# Access Compliance Report

## Public Rights-of-Way

### (Curb Ramps)

Intersection ID: 43522	Main Street: MISTRAL_WY	Cross Street: PALM_BREEZE_LN	Location: S
ADA ID: AD852C582456	Ramp Type: BlendTrans1	Initial Pass/Fail: Fail	Overall Compliance: No
Severity Score: 21.25			
Codes/Mitigation Info/Possible Solution		Field Measurements/Component Compliance

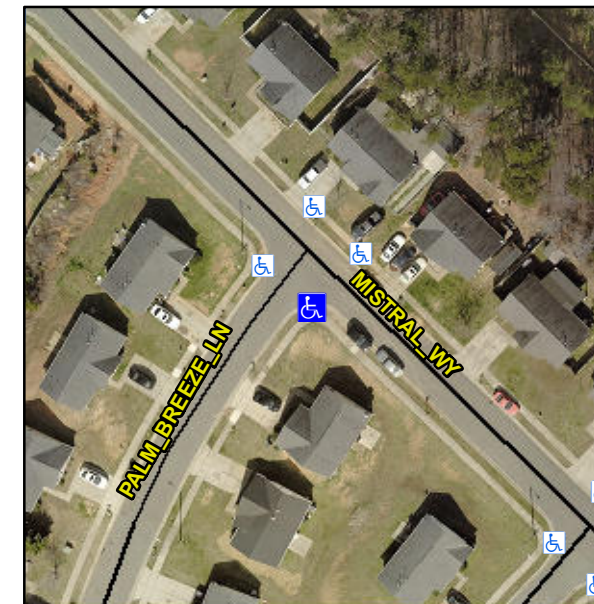
**Not Found, R304.5.1, R304.5.3**

Compliance	Description	Data	Compliance	Description	Data
N/A	Ramp Length (in)	48.0	Yes	BlendTrans Slope (%)	1.7
No	Ramp Width (in)	46.5	No	BlendTrans XSlope (%)	6.4
N/A	Flare Type LT	N/A	N/A	Flare Type RT	N/A
N/A	Flare Slope LT (%)	N/A	N/A	Flare Slope RT (%)	N/A
N/A	Flare Traversable LT?	N/A	N/A	Flare Traversable RT?	N/A
N/A	Landing Length (in)	N/A	N/A	DWS Provided?	N/A
N/A	Landing Width (in)	N/A	N/A	DWS Contrast?	N/A
N/A	Landing Slope (%)	N/A	N/A	DWS Length (in)	N/A
N/A	Landing X Slope (%)	N/A	N/A	DWS Full Width?	N/A
N/A	Landing Curb? (Y/N)	N/A	N/A	DWS Offset (in)	N/A
N/A	Shared Landing?	N/A			
N/A	Gutter Ponding?	N/A	N/A	Gutter Slope (%)	N/A
N/A	Gutter Lip Ht (in)	N/A	N/A	Gutter X Slope (%)	N/A
N/A	Painted X Walk1?	No	N/A	Painted X Walk2?	No
	X Walk 1 Direction	To NE		X Walk 2 Direction	To NW
	X Walk 1 Width (in)	N/A		X Walk 2 Width (in)	N/A
	X Walk 1 Slope (%)	7.8		X Walk 2 Slope (%)	1.3
	X Walk 1 X Slope (%)	3.6		X Walk 2 X Slope (%)	6.5

N/A	Ramp inside XWalk1?	N/A	N/A	Ramp inside XWalk2?	N/A
	Road Slope (%)	6.6		Clear Space?	N/A
	Road X Slope (%)	4.2	N/A	Clear Space to XWalk (in)	N/A
N/A	Any Obstructions?	N/A	N/A	Storm Grate/Utility Hazard?	N/A
	Obstruction Type			Storm Grate/Utility Type	
		N/A			N/A
			Yes	Surface Condition? (G/P)	Good
			No	Curb Slope (%)	7.3

**Remove & Replace Curb Ramp With Two New Directional Ramps or Equivalent.**
